114 Prince of Wales Road,
Camden, London
NW5 3NE

Basement Impact Assessment
Audit

For
London Borough of Camden

Project Number: 12466-01
Revision: F1

PROJECT TITLE 114 Prince of Wales		DRAWING TITLE Existing Site Plan				REVISIONS				SCALE AT A3 1:200	
	CLIENT Lorenzo Calzavara		DRAWING No PRWLS-L001				REV:	DESCRIPTION:	BY:	DATE:	DATE: Dec 2015	
								Existing Drainage Plan			REV

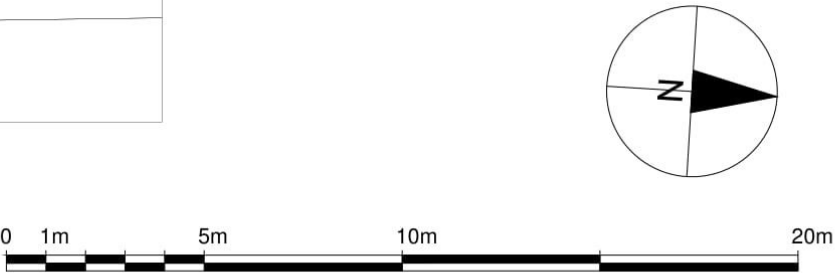
Gulley 1 collects rain water from the flat roof over the existing outrigger. An exposed soil pipe connects this to the manhole

Surface water runs down the concrete hard standing into the existing lightwell and into gulley 2

The rainwater from gulley 2 goes directly under the building towards the front of the property and into the mains sewer

The attached plan illustrates the way in which the surface water drains and this will remain the same although a new gulley will be created and the original manhole will remain the same but be double sealed. Level of surface water will remain unchanged. Report LCAL 3303 Appendix E Section 4 details that the drainage will be designed to restrict outflow to sewer to existing levels and that SUDS will be considered. Large planters will be placed in the hard covered garden to mitigate a small level of rainfall.

<div>PROJECT TITLE</div> <div>114 Prince of Wales</div> 	DRAWING TITLE		REVISIONS			SCALE AT A3	
	Proposed Site Plan		REV:	DESCRIPTION:	BY:	DATE:	1:200
	CLIENT			Proposed Drainage Plan			DATE.
	Lorenzo Calzavara						Mar 2017
	DRAWING No						REV
	PRWLS-L101

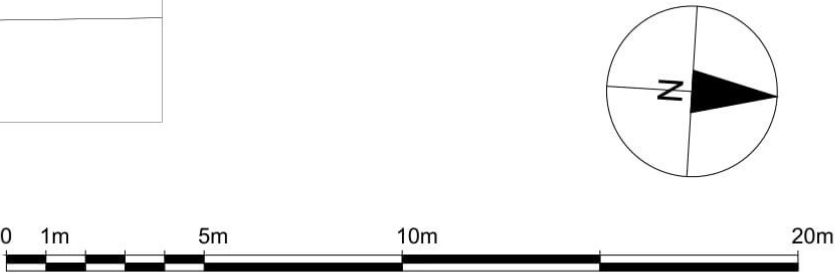
Surface water from both levels of hard standing will run into the new gully

The original manhole 1 will be double sealed but remain unchanged

Water from both flat roof levels will run across gutters and down downpipes into the new gully
